COM Commit Requests: 4p6_6 Align to D1.2 Annex 178A MLSD

Rich Mellitz, Samtec

COM Ad Hoc October 29, 2024

Added temporary plot if MLSD is used

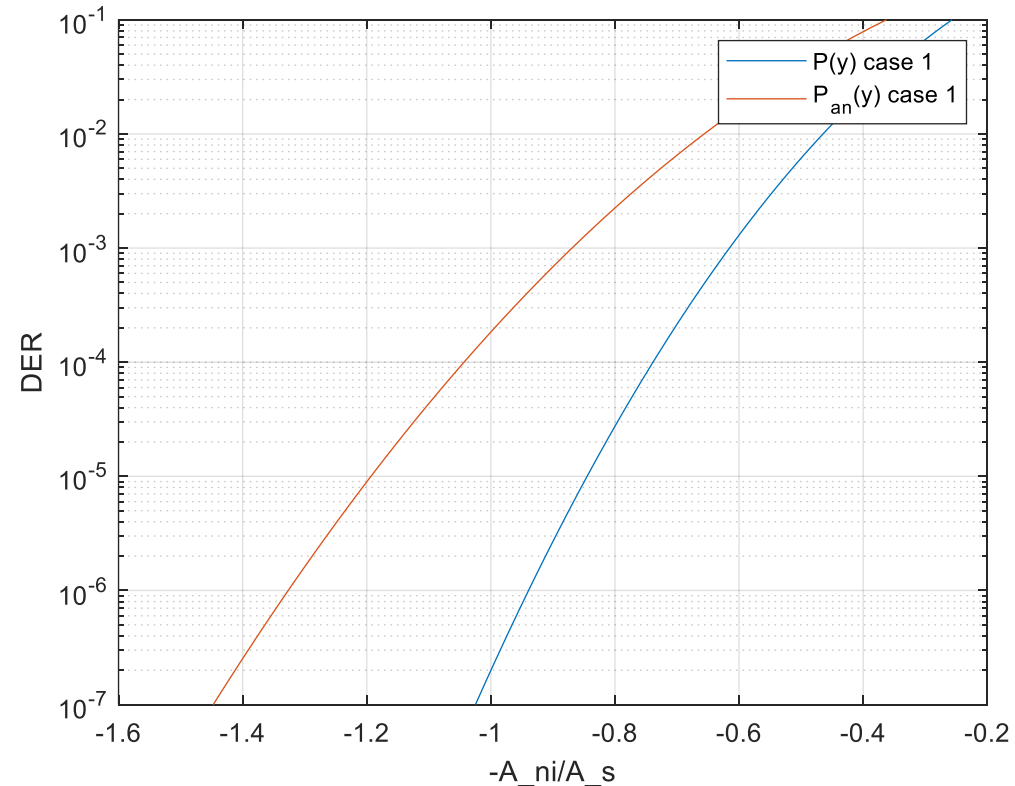
- Visualize new CDFs for MLSD
